<b>Item No:</b> 7.1 & 7.2	<b>Classification:</b> Open	<b>Date:</b> 19 October 2022	<b>Meeting Name:</b> Planning Sub Committee B
<b>Report title:</b>		<b>Addendum report</b> Late observations and further information	
<b>Wards or groups affected:</b>		North Bermondsey and Surrey Docks	
<b>From:</b>		Director of Planning and Growth

### **Item 7.1: 21/AP/4199 INDIA HOUSE, 45 CURLEW STREET, LONDON, SE1 2ND**

**Project Title:** INDIA HOUSE  
**Project Ref:** 1137  
**Status:** PLANNING  
**Scale:** 1:100  
**Sheet Title:** PROPOSED ROOF PLAN  
**Sheet Ref:** P134 / 1

1 PROPOSED ROOF PLAN  
1:50

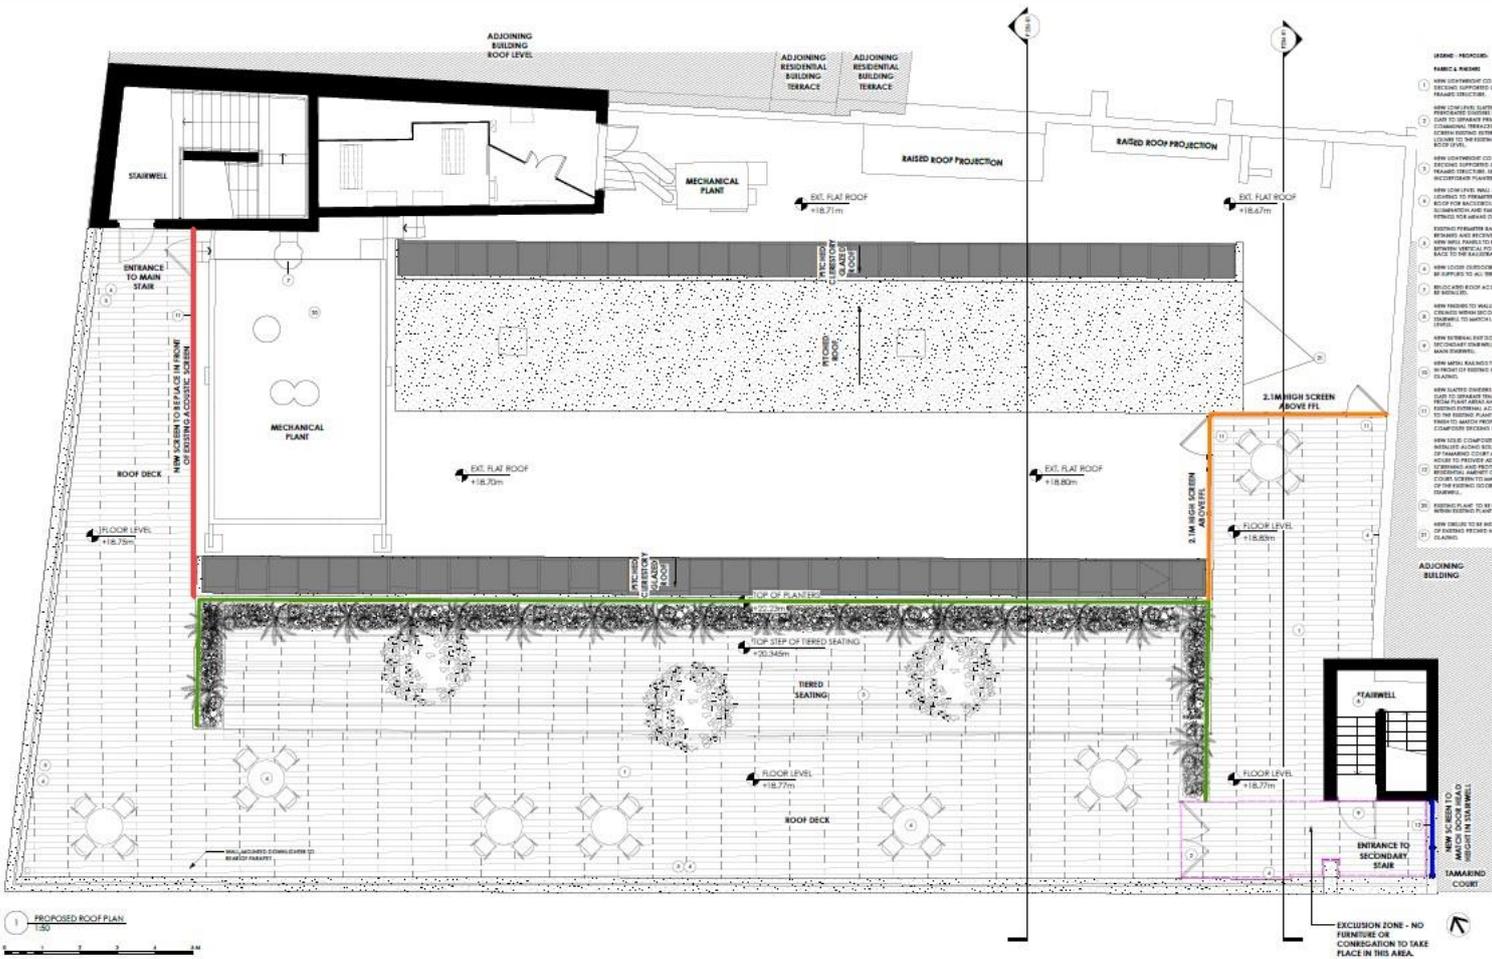
4. The applicant has provided additional information on the heights of the screening for the terrace and these have been included in the presentation. The screen along the top of the seating area is 1.89m, and adjacent to Tamarind Court is 2.2m. Copies will be circulated with the addendum.
5. A materials brochure for the decking has been provided. The applicant states that:

A further condition is recommended to ensure that activity on the roof remains within the defined terraced areas and not elsewhere, so a number of gates should only be used to access other parts of the roof for emergency and maintenance purposes:

The area of the roof defined as a terrace (hatched on the roof plan) in this application shall be the only part of the roof that is accessible to office occupiers of the building. Other non terrace parts of the roof shall not be accessible nor used for informal recreational or business purposes linked to the offices. Any gate giving access to a non terrace part of the roof shall only be used for maintenance or means of escape purposes.
